## **APPENDIX B**

SURFACE WATER QAPP

COMMENTS ADDRESSED IN THE  
REVISED SURFACE WATER QAPP

Table .1 Requested Changes to Surface Water QAPP and Supportive Comments

Figure SW-1. Plot of Average Input Output Flow Rates Relative to Reservoir Water Elevations within Lake Roosevelt as a Function of Time Since Upstream Dam Construction (30-Year Averages)

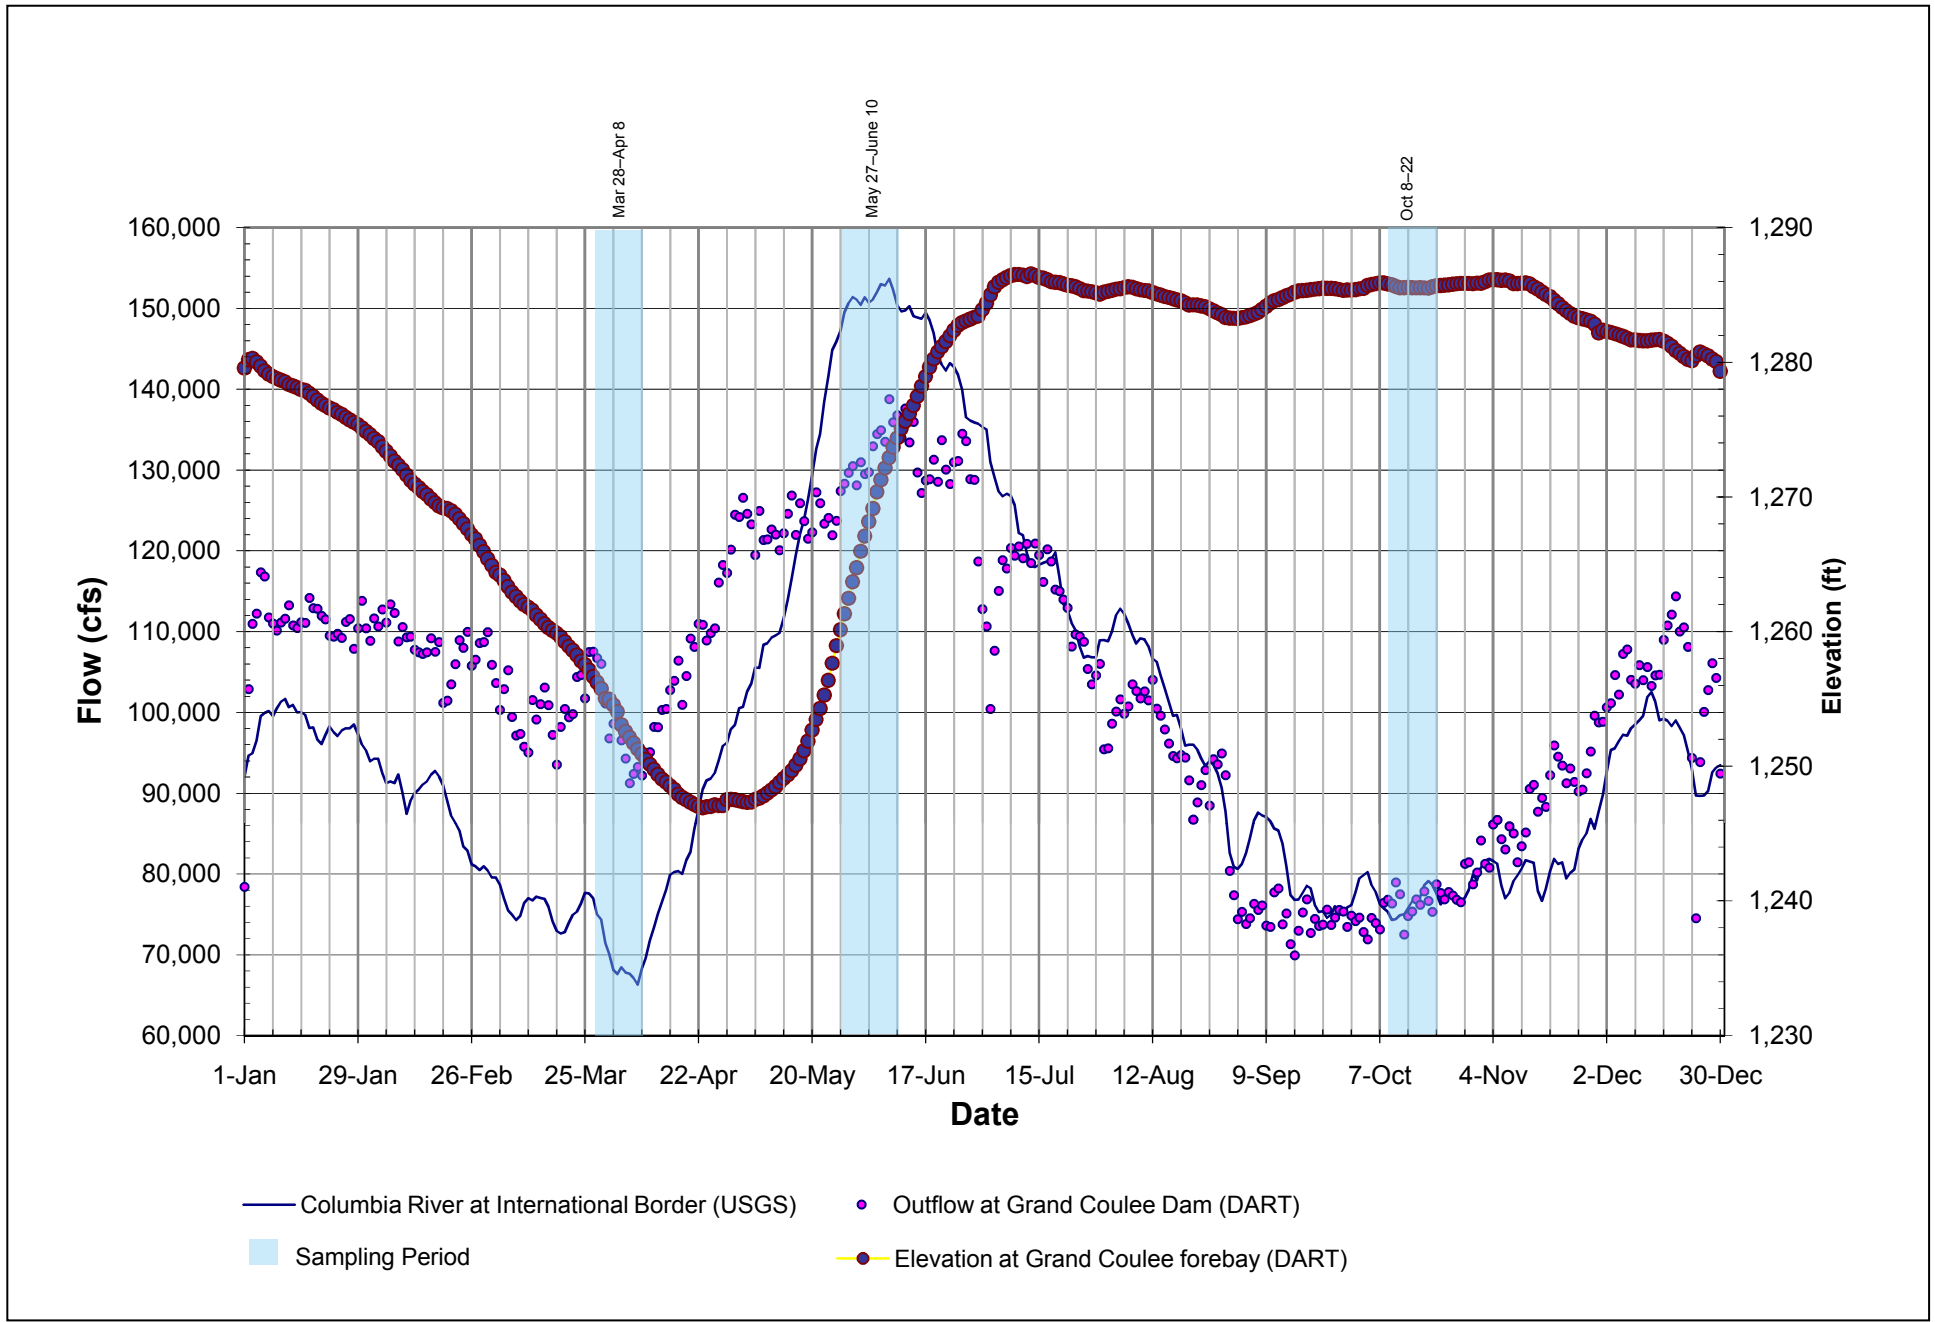
Comment No.	Section	Page	Line	Requested Change	Comment	Response to Comment - Proposed Revision
2				<b>Include in text, as appropriate</b>	<p>The HHRA exposure media of principal concern is disturbed, shallow surface water (includes suspended sediment) collected at depositional areas associated with a subset of beaches slated for sampling. The HHRA will rely primarily on disturbed SW samples for:</p> <p>Inadvertent ingestion while swimming, wading or playing at beaches</p> <p>Intentional (subsistence) drinking water (e.g., filling a bottle directly from the river)</p> <p>Swimmers from a boat may be exposed to undisturbed pelagic SW</p>	Section A7.1.1 <u>Conceptual Model and Data Needs/Uses</u> of the revised document will be modified to specify the disturbed shallow surface water as the exposure media of principal concern for the HHRA.
3				<b>Modify text in QAPP to match work plan</b>	Several surface water-related comments submitted in response to the RI/FS Work Plan apply to the current version of the SW SAP. Specifically, the changes in Sections 5.1 and 5.2 of the RI Work Plan regarding the sources and usability of historical data, comparability of historical data sets, and revisions to text concerning conditions in the Pend Oreille River (the redline version of the RI Work Plan, dated 12/5/08 indicates these changes).	Section A5.2 <u>Overview of Existing Surface Water Data</u> and <u>Appendix D</u> of the surface water QAPP will be reviewed and modified to ensure consistency with the December 2008 RI/FS work plan. The redline-strikeout section on the RI/FS work plan pertaining to the Pend Oreille River (Section 5.2) has been provided by EPA and text will be modified accordingly. Language related to the sources and usability of the data will also be revised to be consistent with Section 5.1 of the RI/FS work plan.
